COMMITTEE REPORT BY THE DIRECTOR OF ENVIRONMENT AND NEIGHBOURHOOD SERVICES READING BOROUGH COUNCIL PLANNING APPLICATIONS COMMITTEE: 5th September 2018	ITEM NO.
--	-----------------

App No.:180855 ADJ (South Oxfordshire District Council ref P18/S1522/O)

Address: Land adjacent to Highdown Avenue, Emmer Green, Reading RG4 8QS

Proposal: Outline application to establish the principle for use of the site for Class C3 Residential occupation; means of access from Highdown Hill and density of Class C3 residential to be determined under this application.

Figure 7.1 Illustrates what various carriageway widths can accommodate. They are not necessarily recommendations.

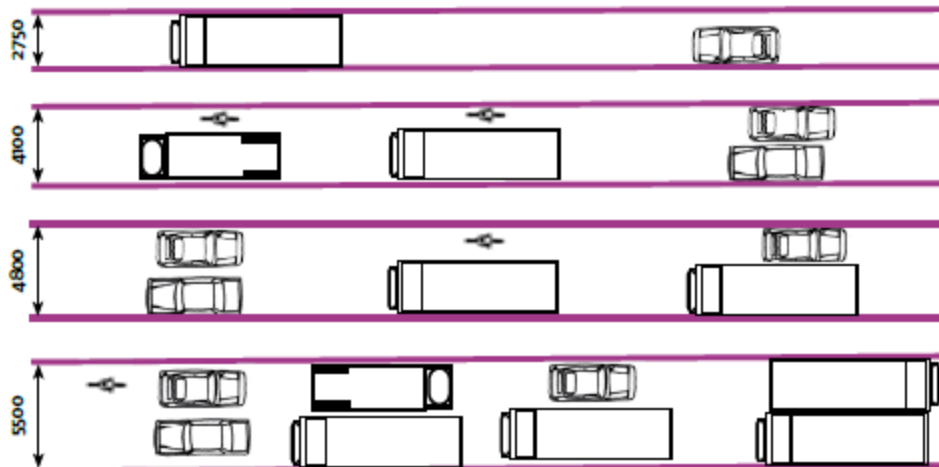
Figure 7.1 (below) of Department for Transport document Manual for Streets identifies carriageway widths to meet the required demands.

All of the above highlighted sections are appropriate in this case and a carriageway width along with the addition that National Cycle Network Route 5 which also runs along Highdown Hill Road would need to be taken into account when determining the carriageway requirements. Without including the provision for pedestrians the carriageway width would need to be a minimum of 4.8m in width and therefore is unsuitable to accommodate additional traffic.
